DISD - W.W. BUSHMAN REPLACEMENT ELEMENTARY SCHOOL

ZONING CASE # Z 212-271

09.26.2022

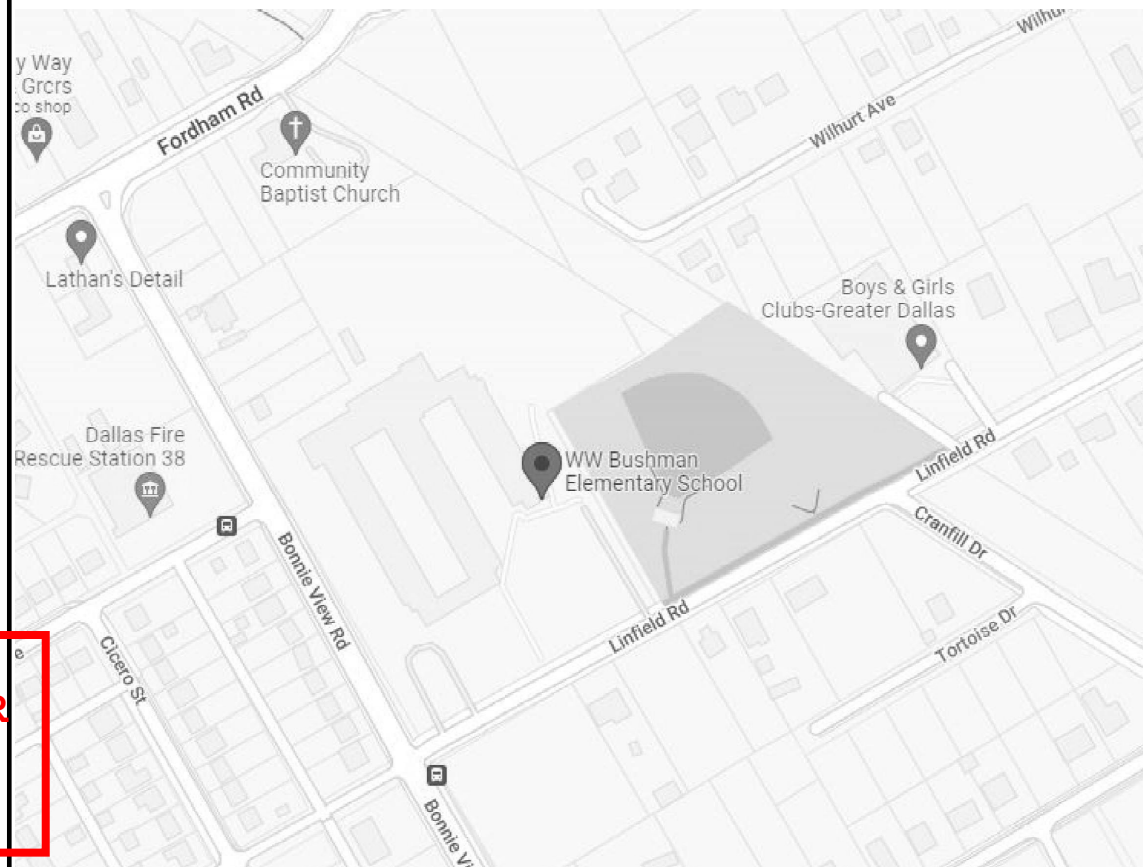
Staff comment:  
REVISE PLAN TO REMOVE  
VISIBILITY OBSTRUCTIONS.

Staff comment:  
ENSURE THAT SUP SITE PLAN AND  
TMP ARE CONSISTENT BEFORE SUB-  
MITTING REVISIONS.

Staff comment:  
SHOW 20' X 20' VISIBILITY  
TRIANGLES AT ALL POINTS OF  
INGRESS/EGRESS, TYP.

1. REVISE INTERNAL CONNECTION WITH PERPENDICULAR INTERSECTION PER ENGINEERING STAFF COMMENTS.
2. ADD PAVED PEDESTRIAN PATH ALONG CIRCUITOUS DRIVEWAYS AND/OR PEDESTRIAN ROUTES THROUGH THE CAMPUS FROM ALL ACCESS POINTS. (ACCESS ROUTES SHOULD BE DESIGNED IN A MANNER THAT WILL ALLOW PEDESTRIANS TO ACCESS BUILDING ENTRIES WITHOUT THE NEED TO CROSS INTERNAL VEHICULAR TRAFFIC/QUEUE LINES.)
3. NOTE: 5'-0" WIDE SIDEWALK IS MINIMUM REQUIRED FOR ADA COMPLIANCE; HOWEVER, STAFF RECOMMENDS MINIMUM 6'-0" WIDE SIDEWALKS AT SCHOOLS.
4. OTHER PEDESTRIAN AMENITIES SUCH AS BENCHES, TRASH CANS, AND PEDESTRIAN SCALE LIGHTING ARE RECOMMENDED AT REGULAR INTERVALS ALONG STREET FRONTAGES, HOWEVER, THESE ITEMS ARE NOT CURRENTLY REQUIRED BY CODE.

Staff recommended language:  
MINIMUM 6'-0" WIDE SIDEWALK  
w/ MINIMUM 5'-0" WIDE BUFFER  
MUST BE PROVIDED ALONG THE  
ENTIRE LENGTH OF ALL STREET  
FRONTAGES, TYP.

Staff comment:  
NOTE: CONSIDER ADDING SIDEWALK  
LANGUAGE AS AN SUP CONDITION TO  
COMMUNICATE INTENT THAT SIDEWALKS  
AND BUFFER ARE TO BE PROVIDED AS  
NOTED ABOVE (i.e. TO ELIMINATE THE  
POSSIBILITY OF A SIDEWALK WAIVER  
BEING OBTAINED FOR THE PROPERTY).

Staff comment:  
EXTEND THROAT OF  
DRIVEWAY TO AVOID  
ABRUPT TURN.

Staff comment:  
TABLE HAS INCORRECT DATA. CONFIRM  
THE MATH AND CORRECT THE DATA.
